Work Order ID 52136

Item Name: Skidtube LH

DART SERVICE INSTRUCTION

TO AMEND INSTALLATION INSTRUCTIONS IIN-D209-669 REV. B

5.0 PARTS LIST

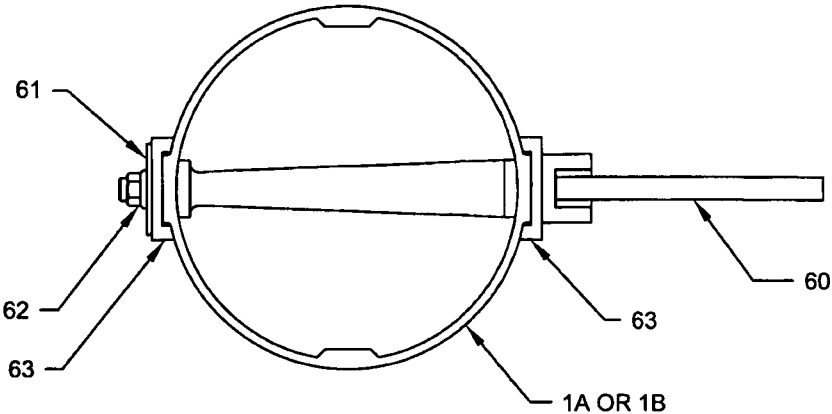
- a) REPLACE THE D2968-041 TOW RING WITH THE D3407-041 TOW RING ASSEMBLY.
- b) REPLACE THE D2736-1 AND D2736-3 GHW LUGS WITH THE D3405-041 AND D3405-043 LUG ASSEMBLIES.
- c) AMEND THE PARTS LIST IN SECTION 5.0 OF INSTALLATION INSTRUCTIONS IIN-D209-669 REV. B AS SHOWN ON PAGE 2 OF THIS DSI.

NOTE: ALL INSTALLATION FASTENERS FOR THE ABOVE CHANGES HAVE BEEN UPDATED. SEE THE AMENDED PARTS LIST ON PAGE 2 FOR DETAILS.

50	4	4	1	1			D3405-041	LUG ASSEMBLY
51	8	8	4	4			AN4C47A	BOLT
52	16	16	8	8			D2570	BUSHING
53	8	8	4	4			MS21043-4	NUT
54			1	1			D3405-043	LUG ASSEMBLY
60	1	1	1	1			D3407-041	TOW RING ASSEMBLY
61	1	1	1	1			D3456-1	WASHER
62	1	1	1	1			MS21043-4	NUT
63	2	2	2	2			D3417-5	WASHER

50	4	4	1	1			D2736-1	GHW LUG
51	8	8	4	4			AN4-46A	BOLT
52	16	16	8	8			D2570	BUSHING
53	8	8	4	4			MS21042L4	NUT (OR MS21042-4)
54			1	1			D2736-3	GHW LUG
60	1	1	1	1			D2968-041	TOW RING
61	1	1	1	1			AN970-4	WASHER
62	1	1	1	1			MS21042L4	NUT (OR MS21042-4)
